**Instructions for Porcel-Line
Type DH-P
Circuit Breakers with
Post Insulator Type Pole Units
(Supplements I.B. 32-253-2)**

Westinghouse Electric Corporation

I.B. 32-253-2A Effective September, 1973

Fig. 8 Trip Linkage Configurations

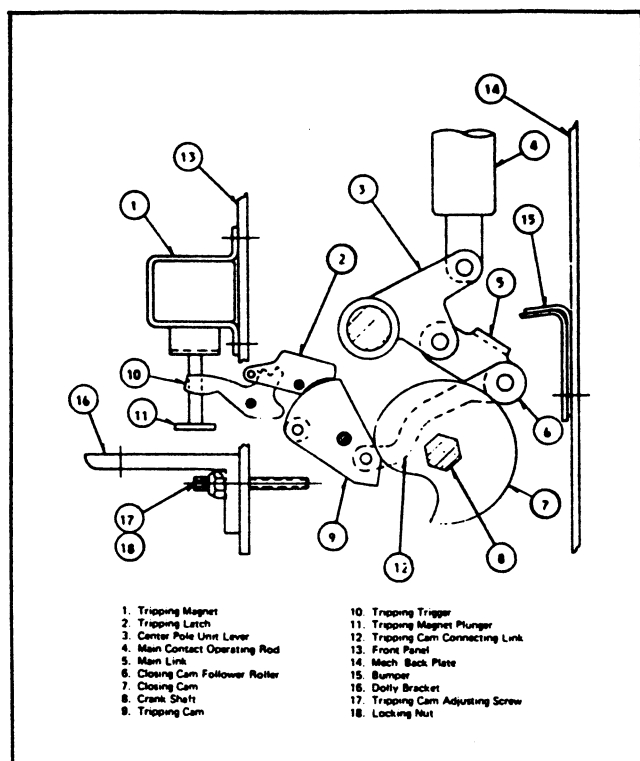
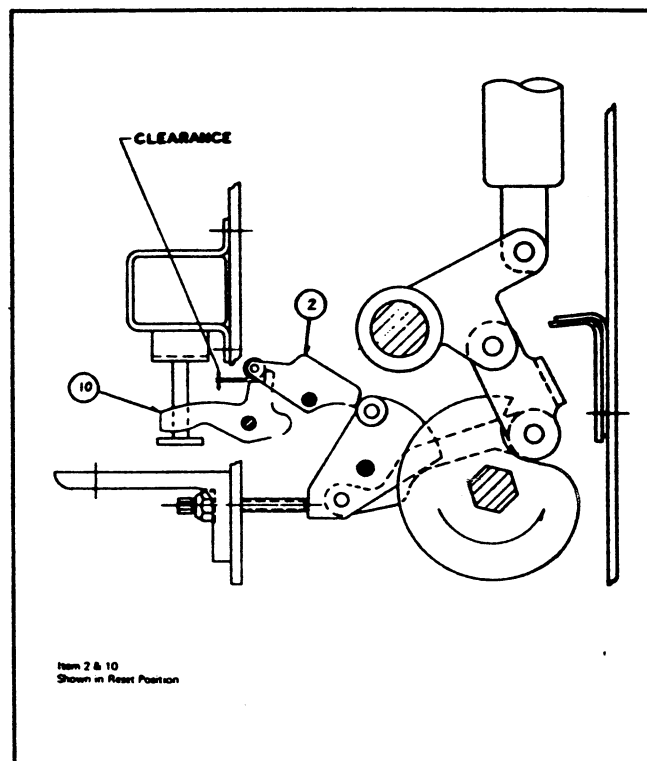
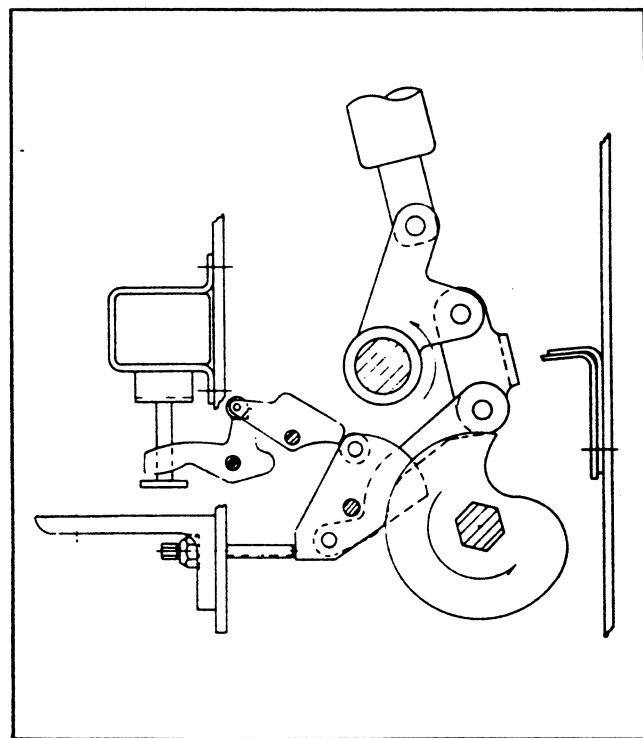
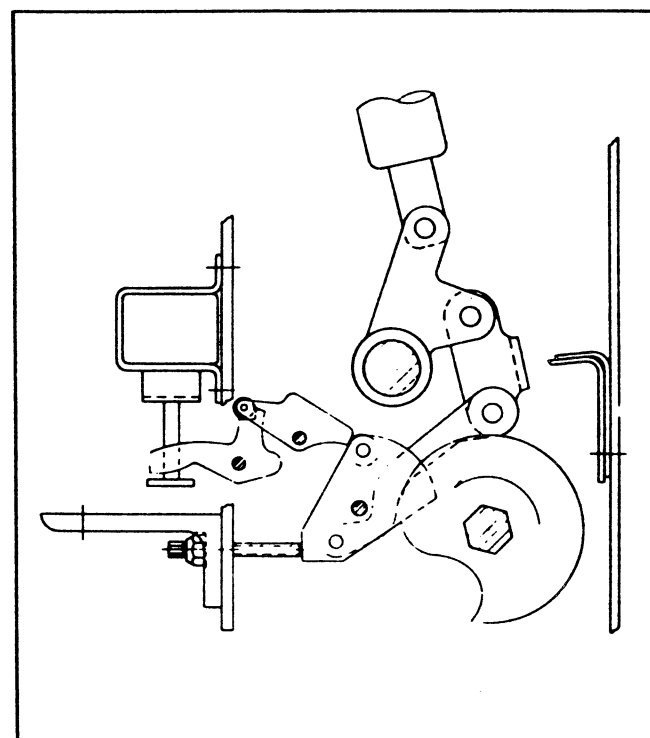
The trip linkage adjustment has been revised for this supplement. The last two paragraphs of Page 47 and the first three paragraphs of Page 48 and Figure 8 of I.B. 32-253-2 are therefore superseded and the following procedure and revised Figure 8 should be used. (Breakers manufactured and adjusted in accordance with the superseded procedures will operate satisfactorily. However if circumstances occur which require that a readjustment must be made the revised procedure should be followed.) With the breaker withdrawn from its switchgear housing remove the transparent plastic cover ("Lift plunger to trip") from in front of the trip coil. Charge the closing spring. With the breaker open and closing spring charged proceed as follows: (Ref. Figs. 8A and 8B).

1. Loosen locking nut (item 18).

2. Referring to Fig. 8B turn the tripping cam adjusting screw (Item 17) "in" - Clockwise - until the roller on the front end of the tripping latch (item 2) positively engages the latch surface of the tripping trigger (item 10) - zero clearance. Do not tighten beyond a nominal positive engagement.

3. Raise the tripping trigger approximately one inch. The trigger will be held up in this position (similar to condition shown in Fig. 8A).

4. Back the trip cam adjusting screw "out" VERY SLOWLY until the trip latch roller and tripping trigger just reset - (as shown in Fig. 8B except zero clearance). Then back the adjusting screw "out" one quarter turn additional. At this setting there will be a small but noticeable clearance between the roller and the tripping trigger.

d. The clearance (Fig. 8B) obtained on most breakers will be in the range .005 to .015 inches. (If a gap gage is used to check the clearance care must be taken to be sure the roller is not raised by insertion of the gage). See Par. 7 following.

7. The normal clearance between the tripping latch roller and the tripping trigger in reset position Fig. 8B will usually be in the range of .005 to .015 inches. This clearance may vary from breaker to breaker and may increase slightly as a breaker accumulates operations. It is desirable to maintain the clearance within the stated range, but breakers with clearances of .032 inches and more have successfully operated. The stated range therefore should be considered as a practical guide. It is not a mandatory precision measurement requiring frequent readjustment.
